Buffer Zone Landscape Design

CVS Commercial Area
Abutting Nadine Road Neighborhood

August 3, 2015

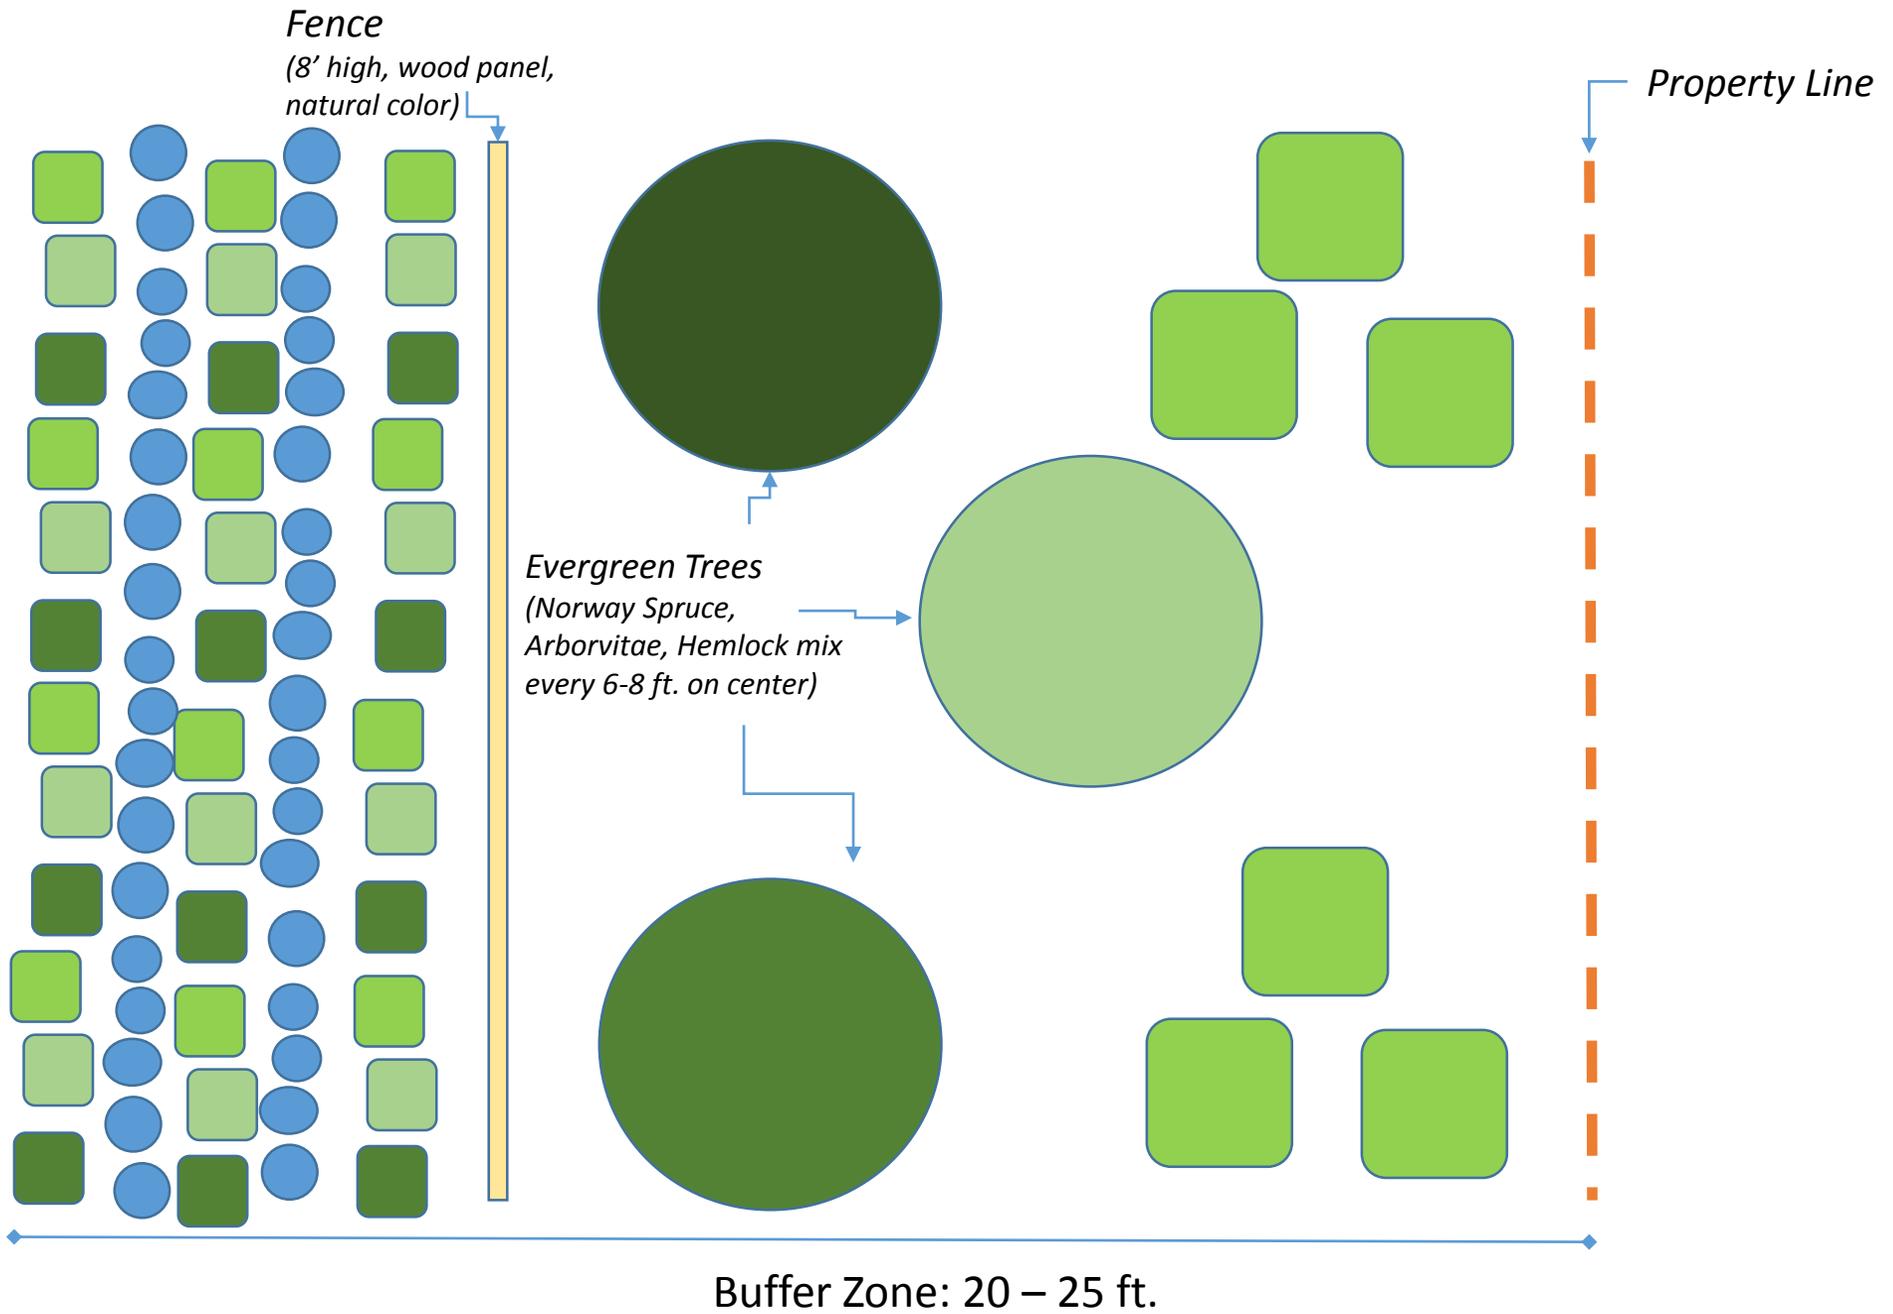
Placing the fence as far north as possible is important, since there needs to be room for trees to grow, which benefits viewers at all vantage points. The note on the fence location on the second slide emphasizes this point.

Fence location: On top level on far north side, at least 10 feet from property line to south, with plantings between edge of top wall and fence.
